City of Bangor

BUTTERFLY VALVE REPLACEMENT AT KENDUSKEAG PUMP STATION AND WASTEWATER TREATMENT PLANT

Addendum No. 1

August 5, 2016

CITY OF BANGOR
SELECTED SEWER COLLECTION SYSTEM INFRASTRUCTURE
KENDUSKEAG PUMP STATION AREA

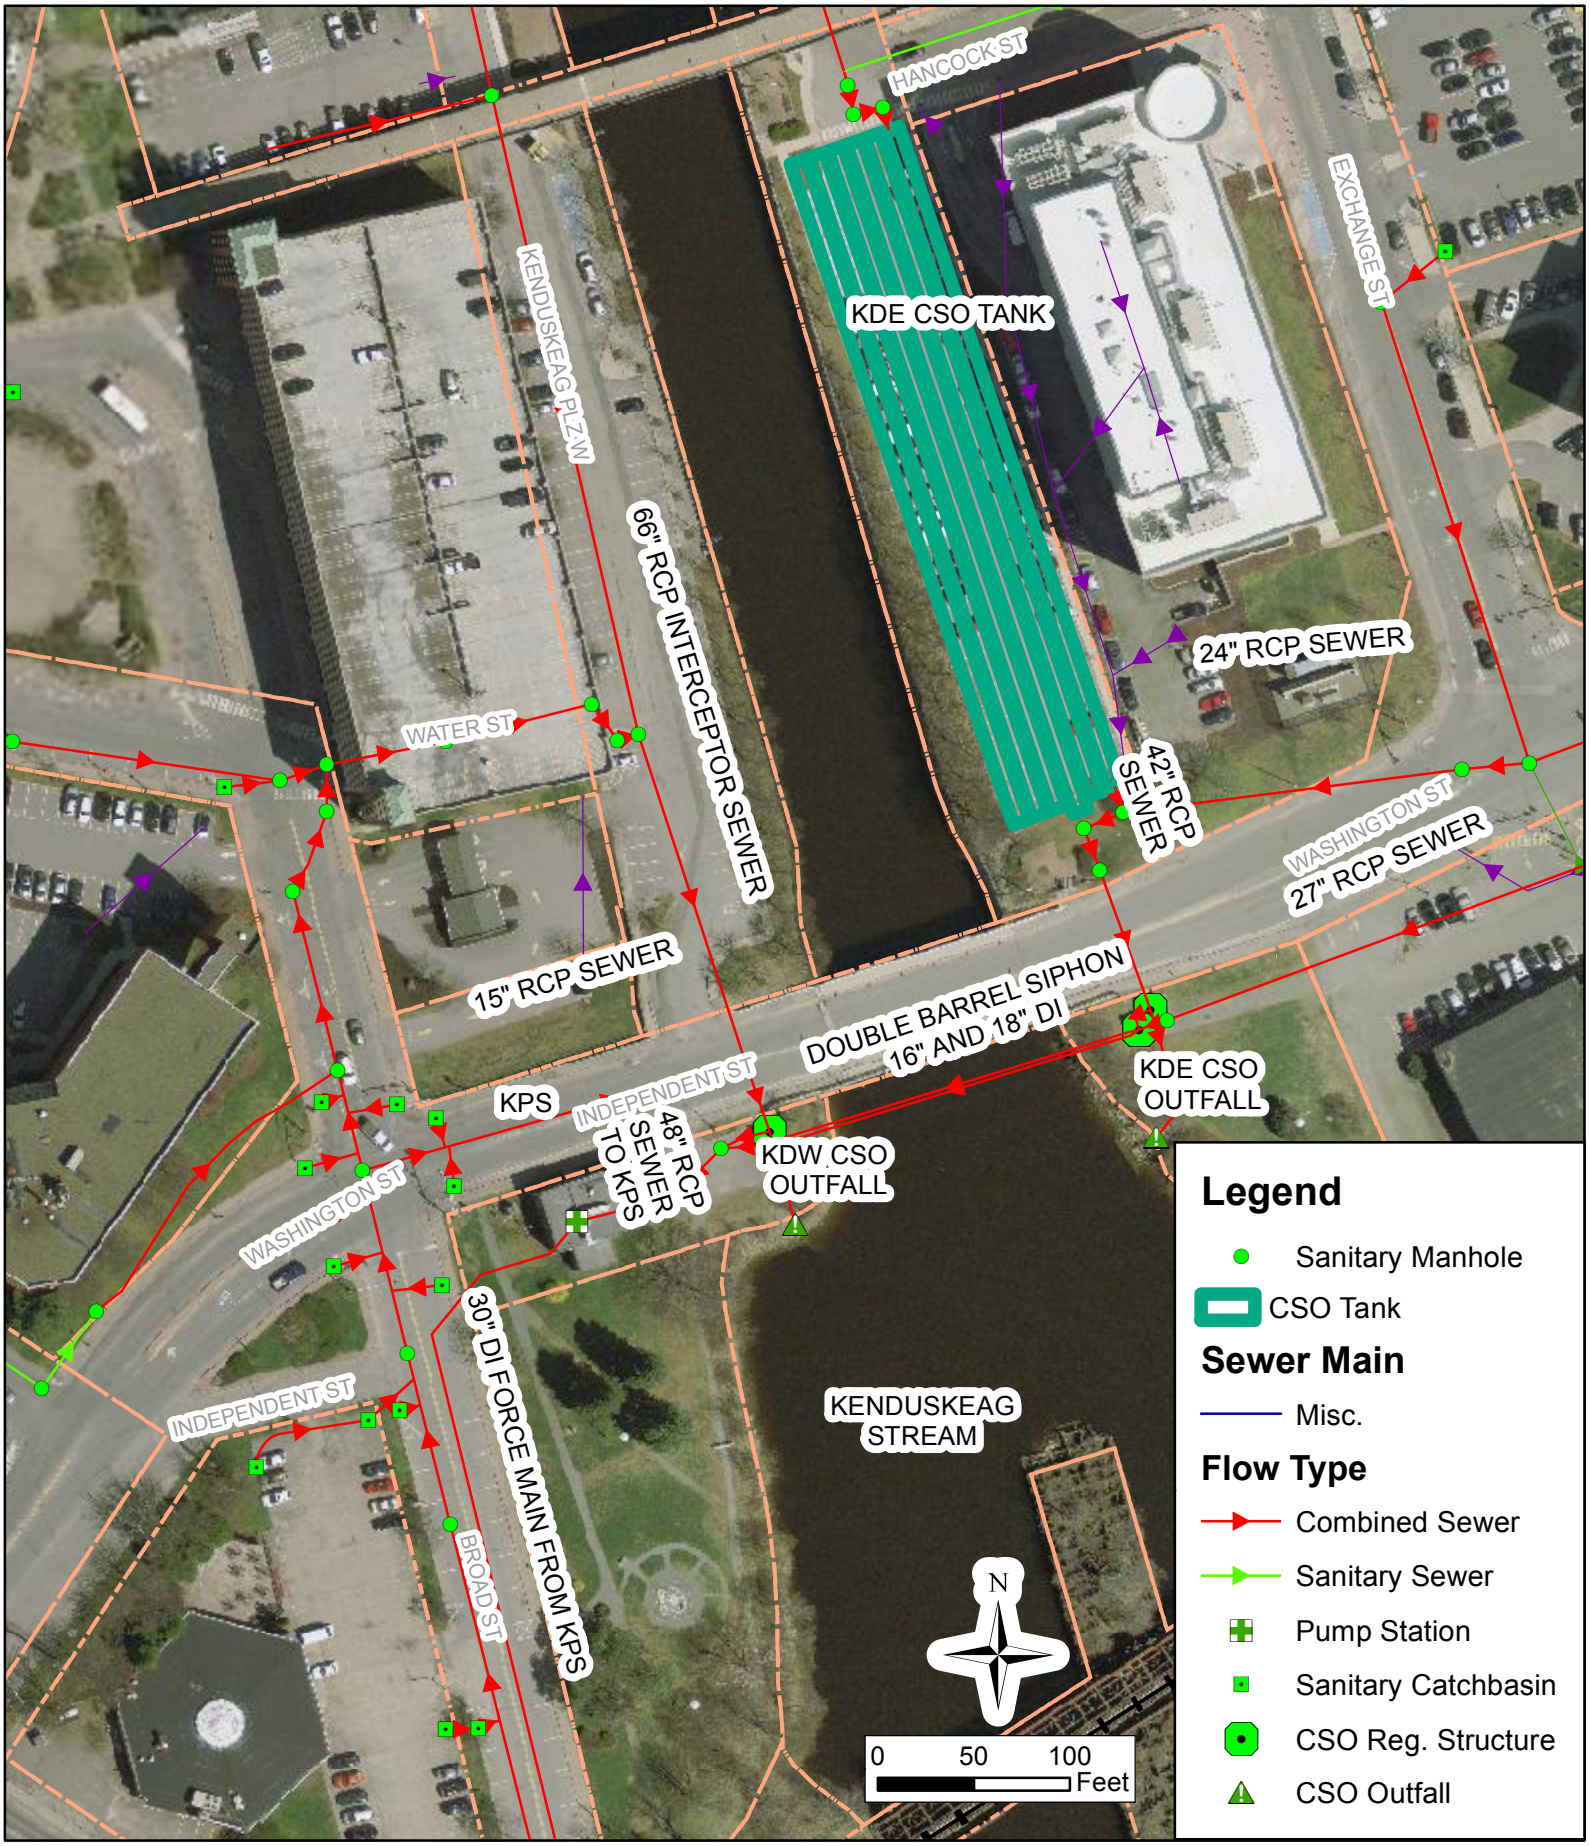
21. How much space is available for a laydown area at KPS?
The parcel that the KPS is located on is shown on the attached GIS map. The City also owns a parking lot immediately north of KPS across Washington Street and a park area immediately south of the KPS parcel. The contractor may request permission from the City to utilize these areas if desired. Use of these areas may need to be coordinated around City events on occasion.

OPERATOR FOR 48" BUTTERFLY VALVE

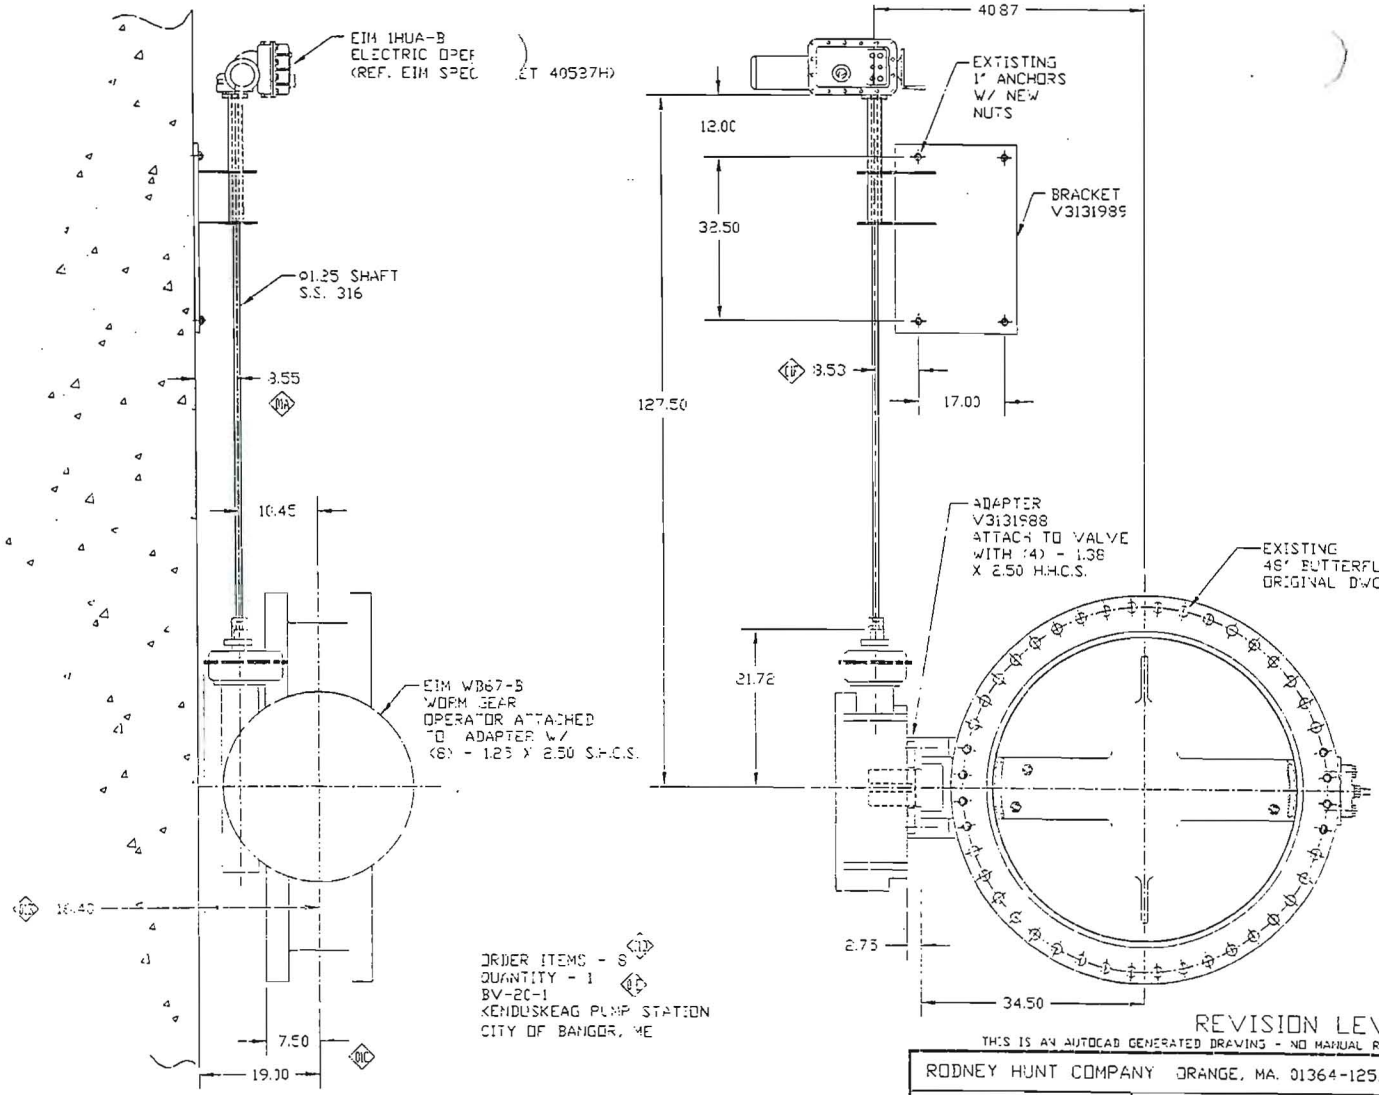
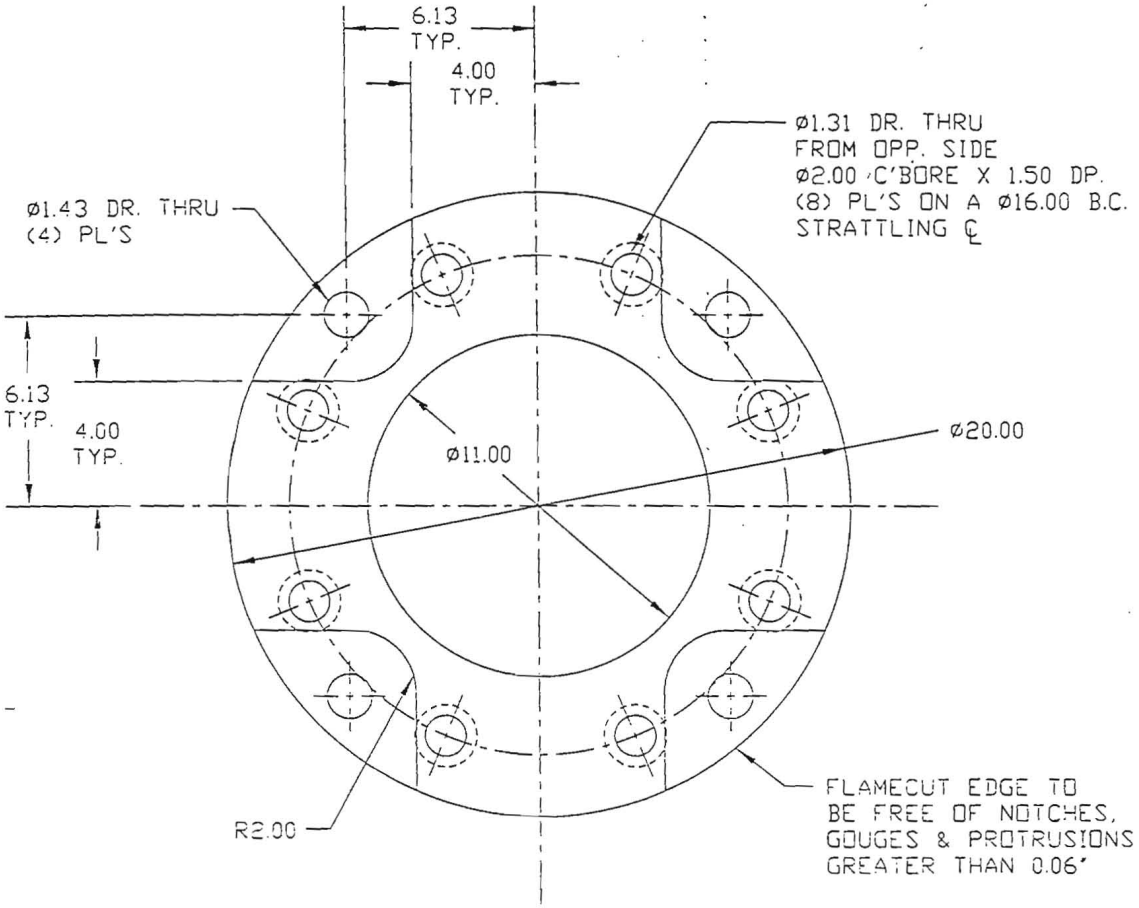
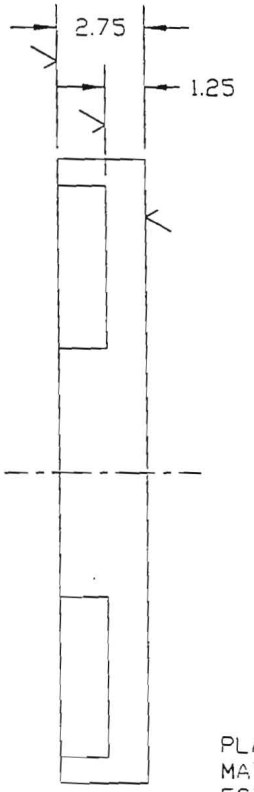
9. Do you have a submittal, cut sheet, or drawing of the existing valves and actuators at the KPS?
Please see attached shop drawings.

11. Do you have a drawing or pictures of the existing valve flange connection at the KPS, specifically access to the bolts and what kind they are?
Please see attached shop drawings.
